92-RPB-189

WATER QUALITY STANDARDS MODIFICATION REQUEST - 300 AREA TREATED EFFLUENT  
DISPOSAL FACILITY

**(RESPONSES TO QUESTIONS FOR WATER QUALITY MODIFICATION REQUEST  
300 AREA TREATED EFFLUENT DISPOSAL FACILITY)**

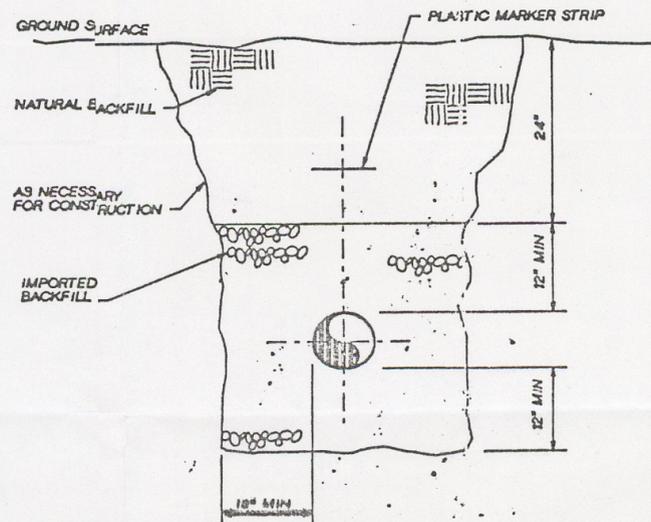
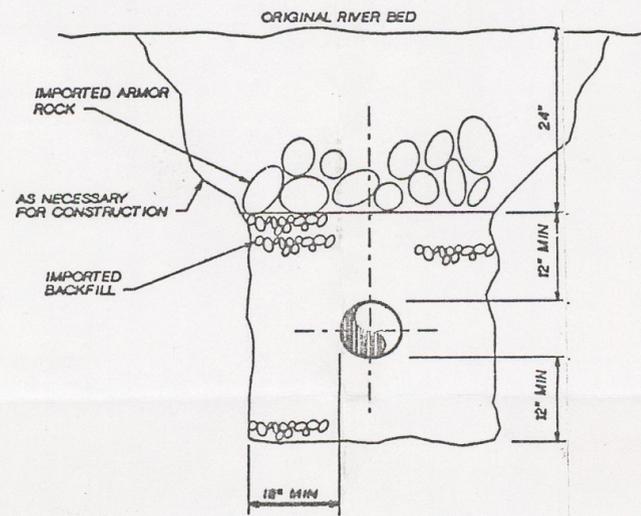
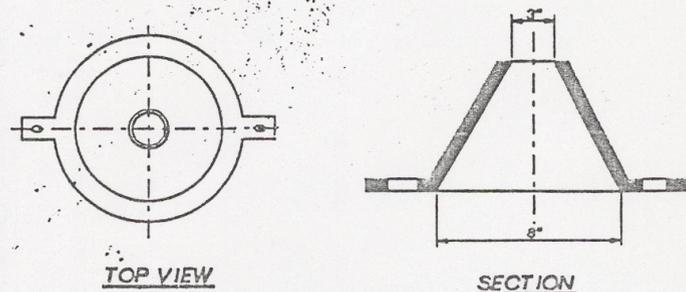
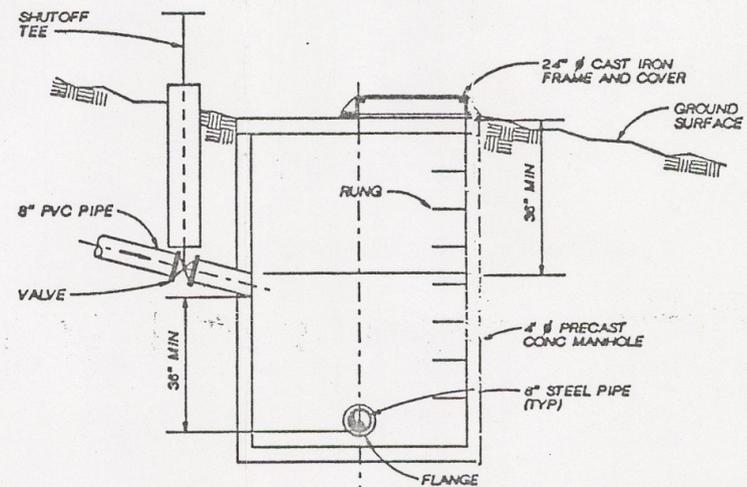
2. Describe the nature of the work. This includes such information as size of pipe, width and depth of dredging work, how the pipe is anchored, and location of pipe and outfall.

Referencing enclosed Drawing C-3, the outfall will consist of an eight inch diameter steel pipe encased in concrete. A minimum trench depth of 56 inches will be dug below the river bed with a corresponding minimum width of 44 inches. The trench will be backfilled with imported aggregate such that the top of the outfall pipe will be at least 36 inches below the original river bed. After the pipe is put in place, the trench will be backfilled with imported aggregate to a depth of approximately two feet below the original river bed. The remaining two feet of trench will then be filled with imported armor rock. The crane for constructing the outfall will be located on a floating barge.
